Homestake Mining Company of California

**RE: Homestake Mining Company of California – Grants Reclamation Project – HMC
Response to NRC Clarification Request for HMC's 03/11/2022 Response to NRC's
09/14/2021 RAI on HMC's 12/18/2020 Revised Request for Amendment to License No.
SUA-1471 to Change the Background Monitoring Location for Radon and Ambient
Gamma Radiation**

HMC Response to NRC Staff Clarification Requests for HMC's License Amendment Request to Change the Background Radon/Gamma Monitoring Location

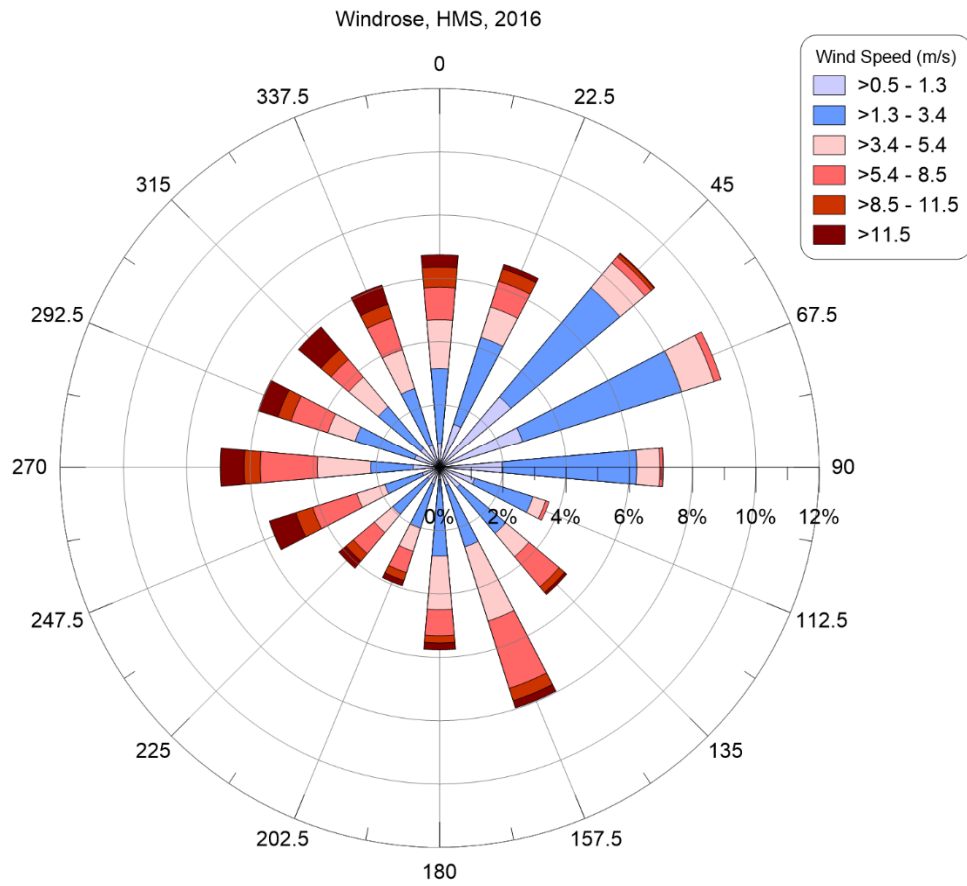
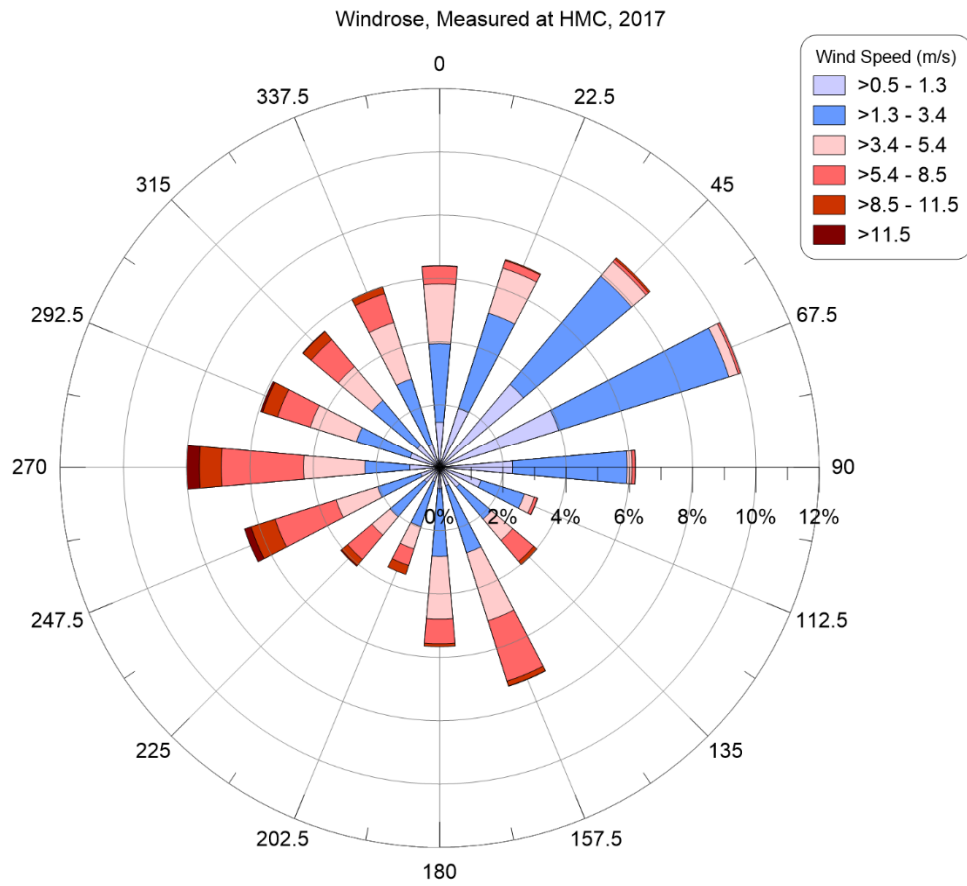
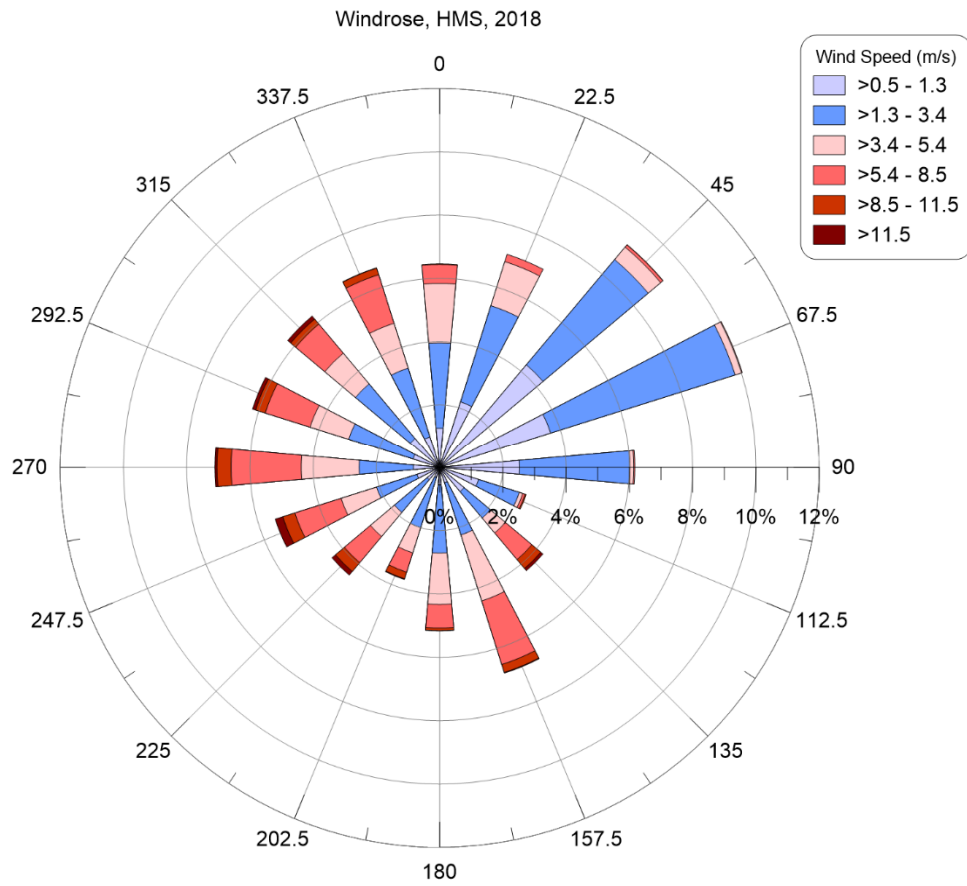
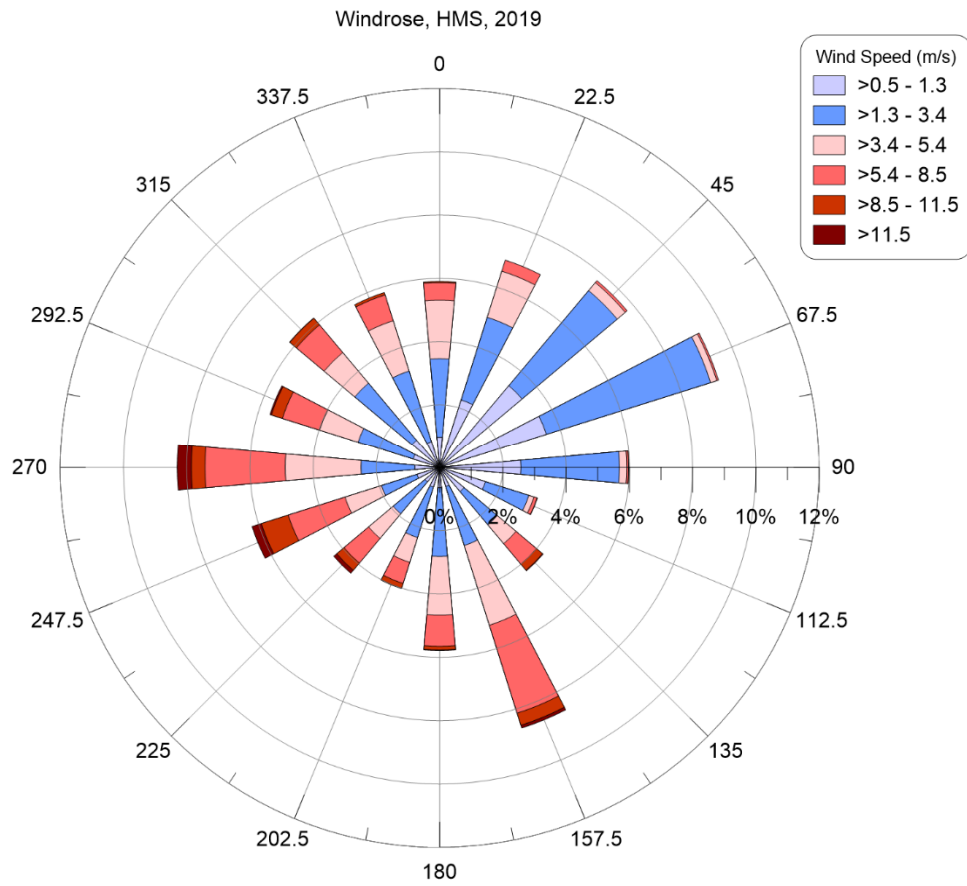
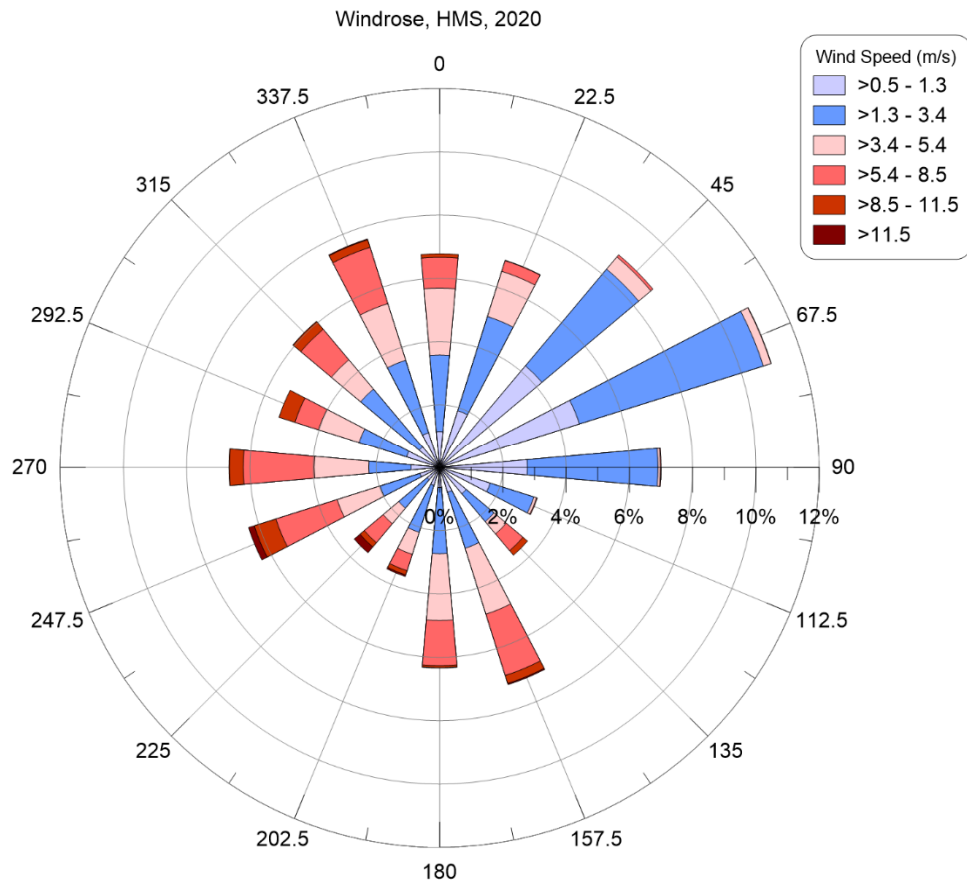
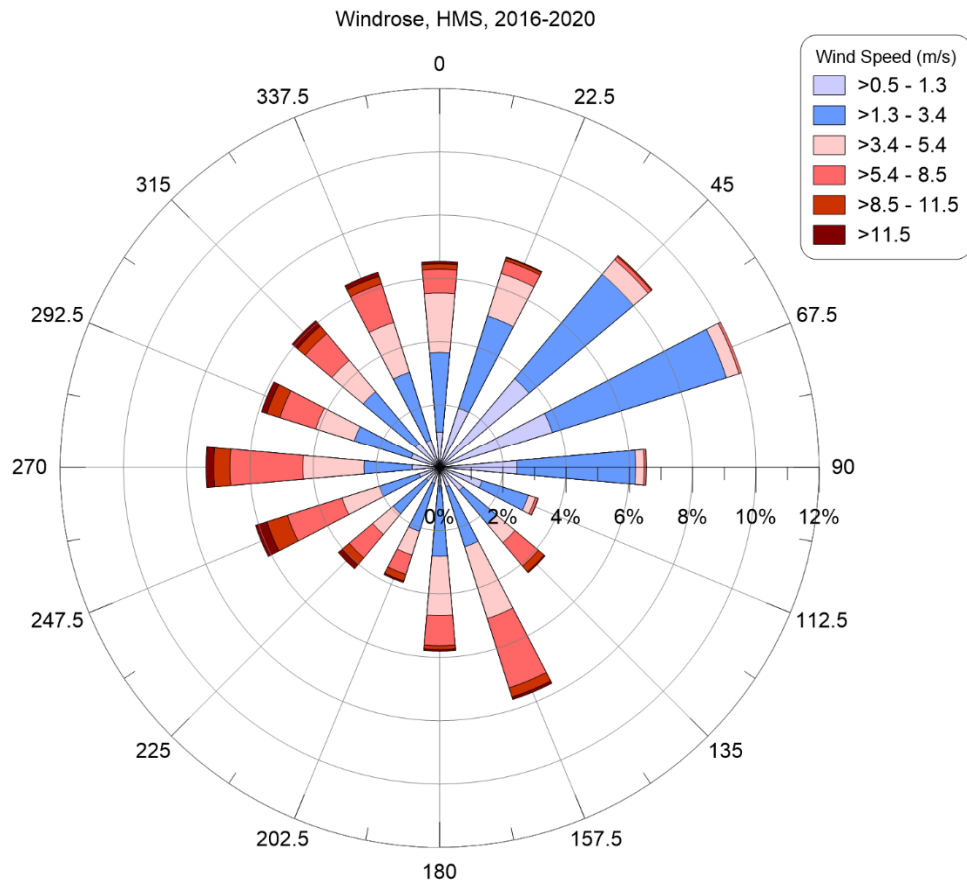
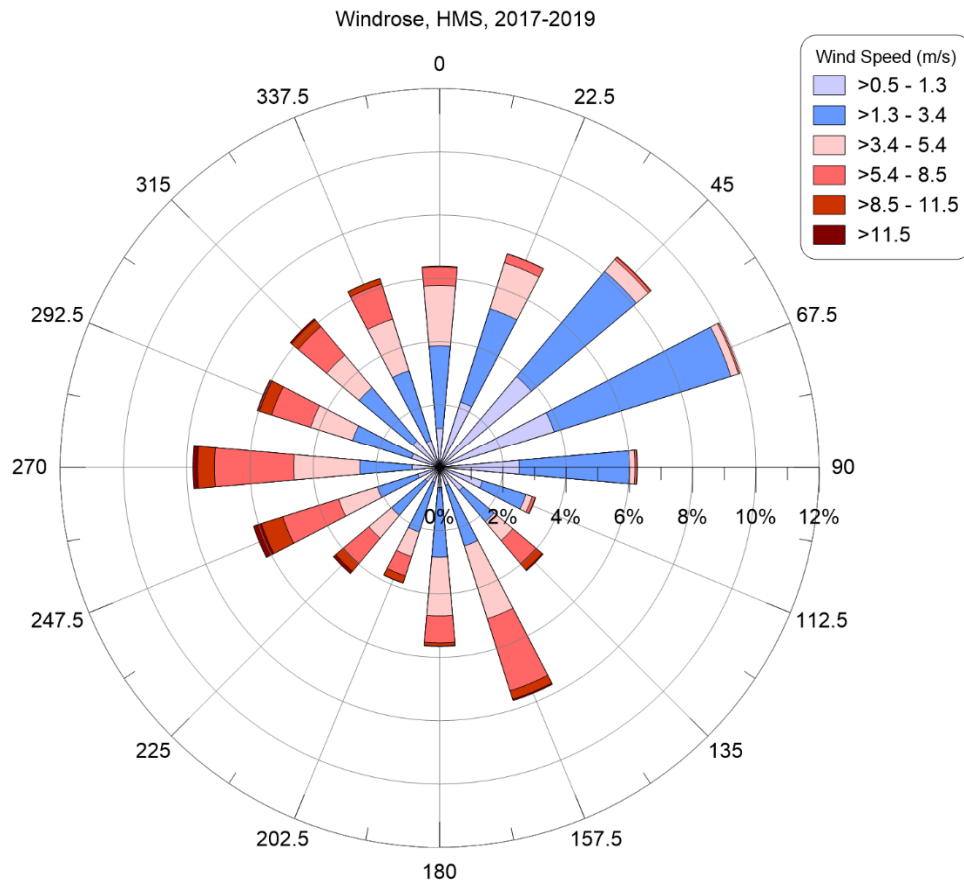
- 1) *Please provide an analysis of the 2017-2019 wind data, demonstrating that it is representative of long-term conditions at the GRP site, as previously requested in RAI-7.*
- 2) *Please provide an analysis of stability class distributions, as indicated in RG 3.63 and the background information for RAI-7.*

- 1) Per the guidance provided in NRC 2017 and 2018, meteorological data at HMC spanning a 5-year period (2016 to 2020) were compared to the data from 2017 to 2019 that were used in the

CALPUFF analysis. Stability class was calculated using the Sigma-Theta method (EPA 2000). Table 1 summarizes these data by year. These data meet the NRC requirement of 5-years of data with at least 3-years of consecutive annual cycles. The data collection recovery rate was greater than 90% for each year which meets the 90% criterion in Reg Guide 3.63 (NRC 1988).

Wind roses for each year and composite wind roses for 2016-2020, and 2017-2019 are shown in Figures 1 through 7.
